Addendum / Addenda

Project Description / Description de projet					
ι	J66 Chiller Replacemer	nt.			
Solicitation No./N° de solicitation	Project No./N° de projet		W.O. No./N° d'ordre de travail		
16-22146	520	01	A1-006954-06-01		
Departmental Representative / représent	ant ministériel		Date		
N	laurice Richard		February 14, 2017		
Notice:		Nota:			
shall apply and be read in conjunction with the original plans and		Cet addenda fait partie intégrale des dossiers d'appel; toutes les conditions énoncées doivent être lues et appliquées en conjonction avec les plans et les devis originaux.

NRC U-66 CHILLER REPLACEMENT

DEMOLITION: FIRST AND SECOND FLOOR REFLECTED CEILING PLAN

5201-A01-ADD#01

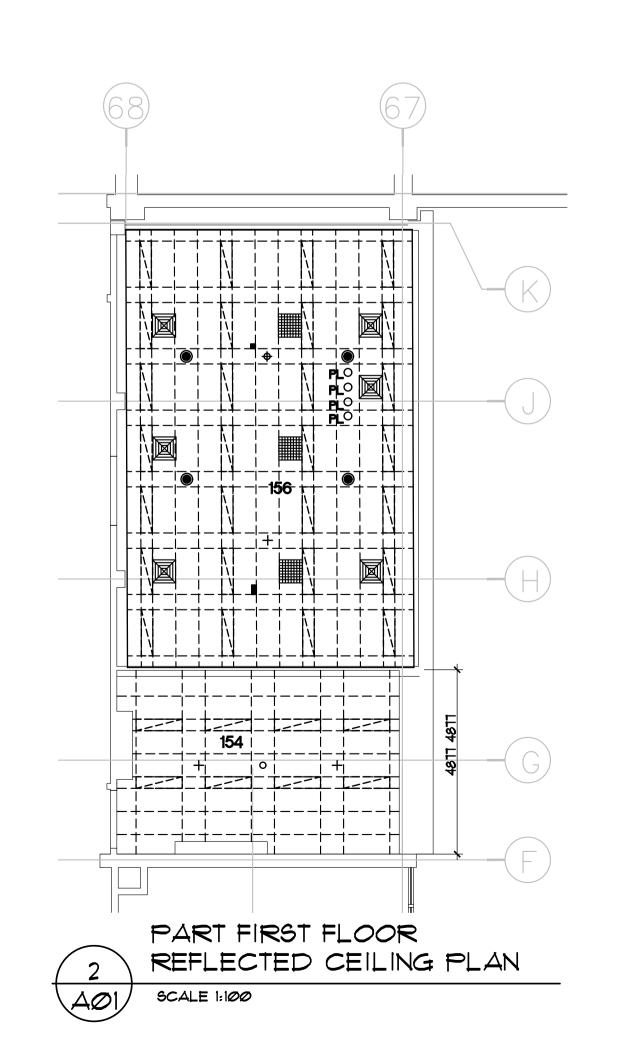
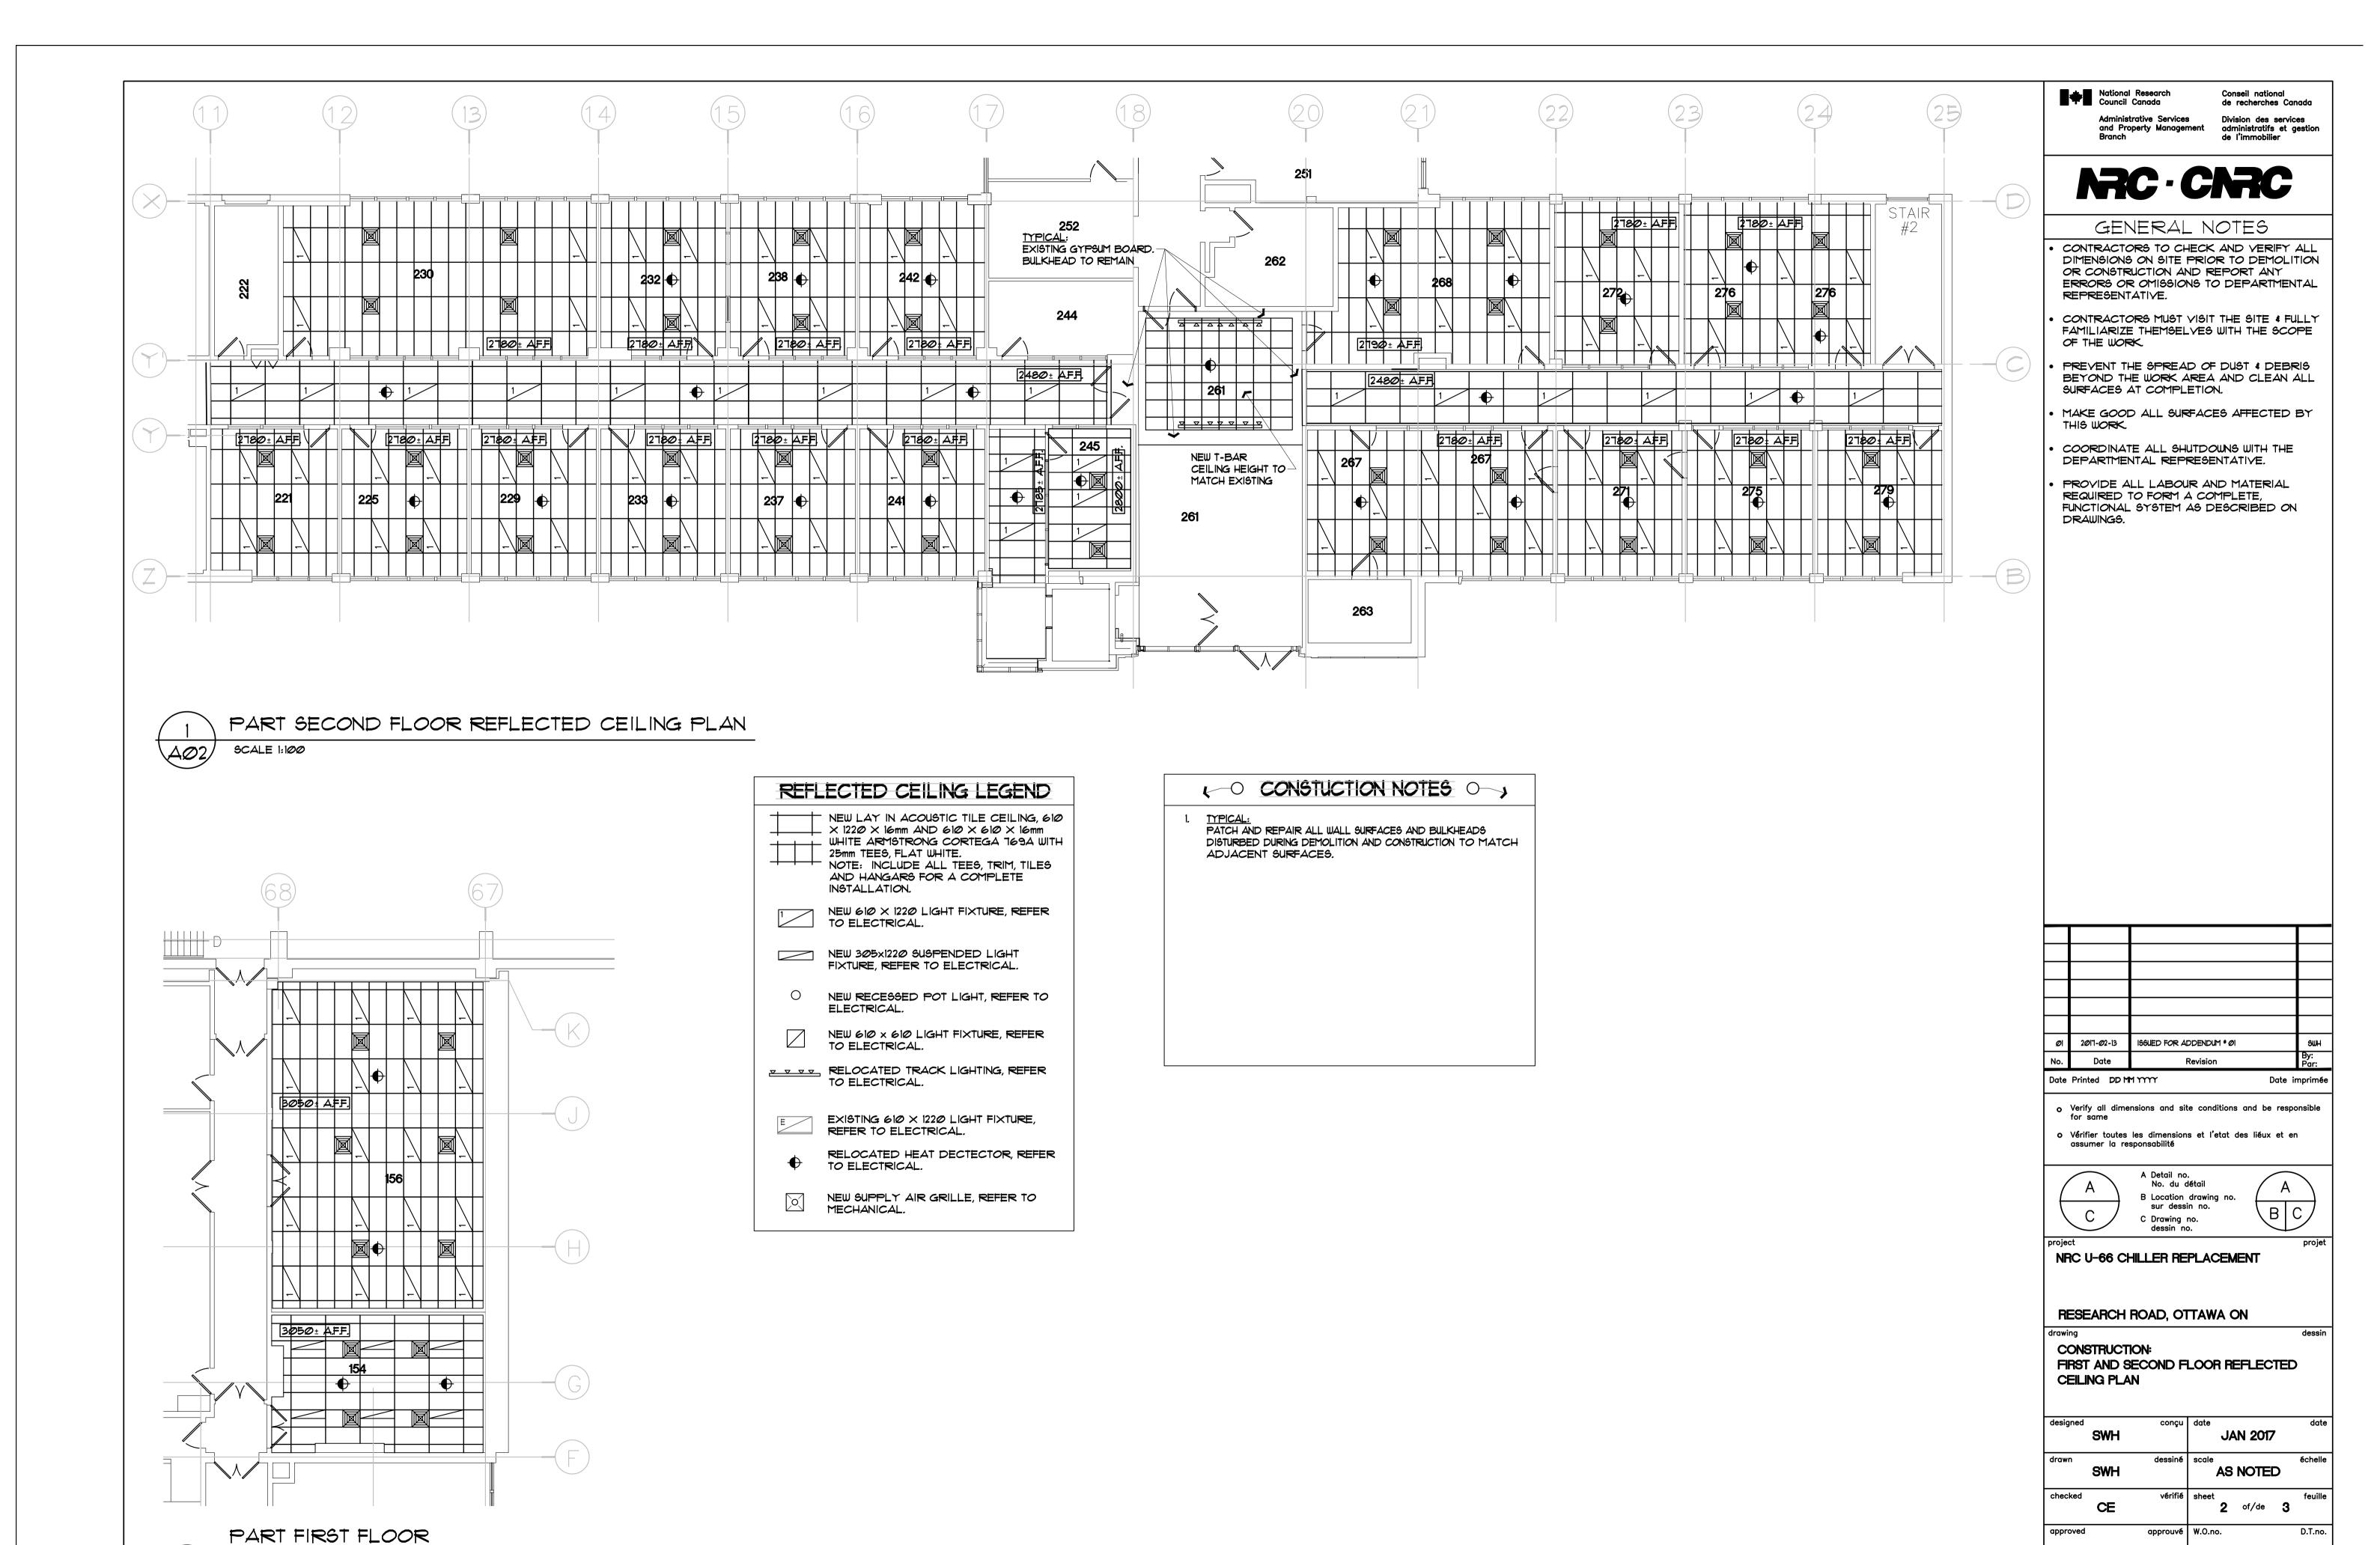
- **5** Delete drawings 5201-A01, 5201-A02 & 5201-A03 and replace with the attached drawings 5201-A01-ADD#01, 5201-A02-ADD#01,5201-A03-ADD#01.
- **6** Delete specification sections: 061000 Rough Carpentry, 072000 Insulation, 075200 Modified Bituminous Membrane Roofing, 081000 Steel doors and Frames, 095100 Acoustical Ceiling Assemblies.
